Document #:PB23116X Issue Date:13 Feb 2020

Title of Change:	AR0330CM Datasheet Update
Effective date:	13 Feb 2020
Contact information:	Contact your local ON Semiconductor Sales Office or Sonya.Yip@onsemi.com
Type of notification:	This Product Bulletin is for notification purposes only. ON Semiconductor will proceed with implementation of this change upon publication of this Product Bulletin.
Change Category:	Documentation Change
Change Sub-Category(s):	Datasheet/Product Doc change
_

Updated the AR0330CM datasheet with new information.

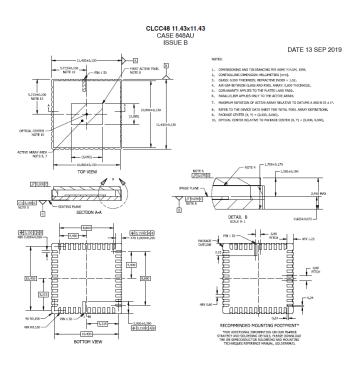
Updated "Table 7, Power-Up Sequence".

6. V<sub>DD\_</sub>MIPI is tied to V<sub>DD\_</sub>PLL in the both the CLCC and CSP packages and must be powered to 2.8 V. The V<sub>DD\_</sub>HiSPi and V<sub>DD\_</sub>HiSPi\_TX
- 7. T4 and T5 use CLOCK unit, for example if EXCLK is 24MHz, 317500 clocks cycle equal to 13.23ms.

5. Replaced CASE 570BH with new CASE 570BJ.

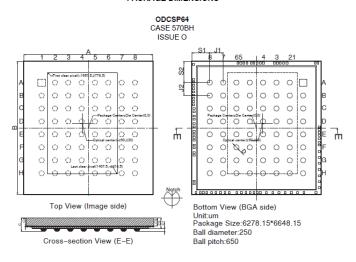
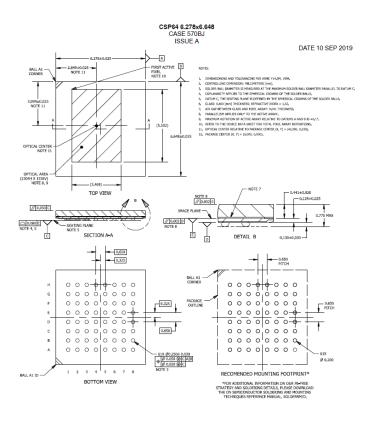
# Old CASE 570BH:

## New CASE 570BJ:
